Telehandler

Description Of Change: New switch kit for the suspension seat group is now used on the machines listed above. The new switch kit is more reliable.

PIP-10087702

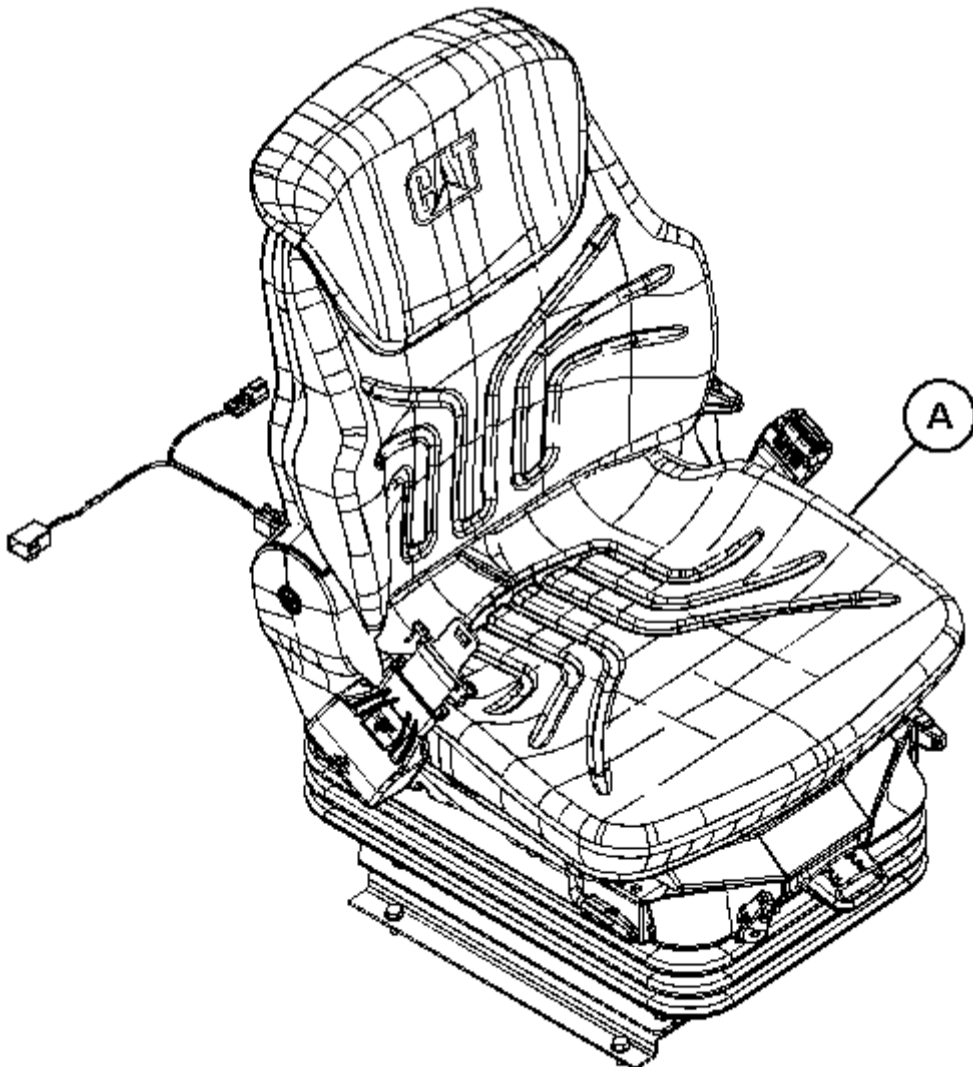
Note: Replace the existing switch kit which has etched design, no green dot, and date code of 2001/8 to 2030/8. Hence the period would be between week 01 and week 30 of the year 2020.

Replace the existing switch kit with new part number listed in Table 1.

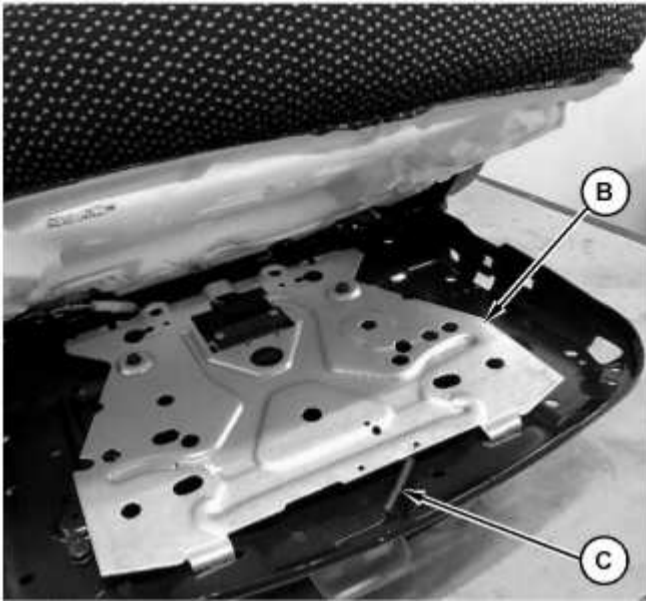
1. Remove and retain seat cushion (A).

Illustration 5
View of area D
(1) 627-9841 Switch Kit

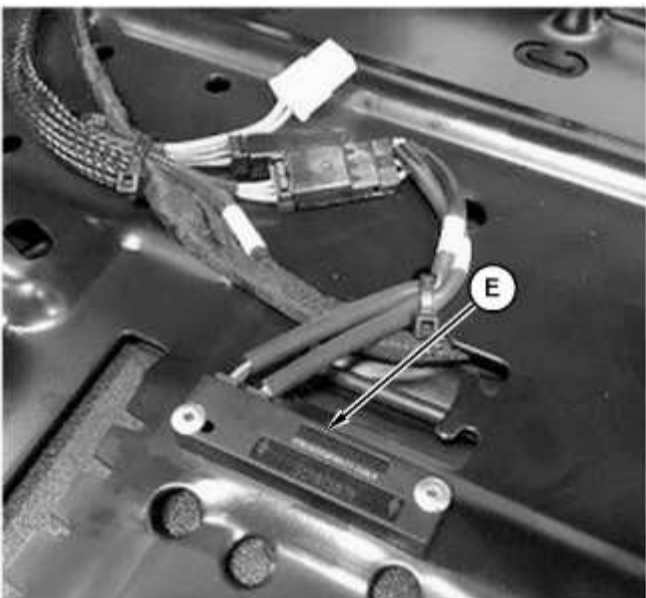
2. Release spring (C) from silver plate (B). Remove and retain silver plate (B) to access the switch kit.

3. Remove and discard existing switch kit (E).

4. Install new switch kit (1).
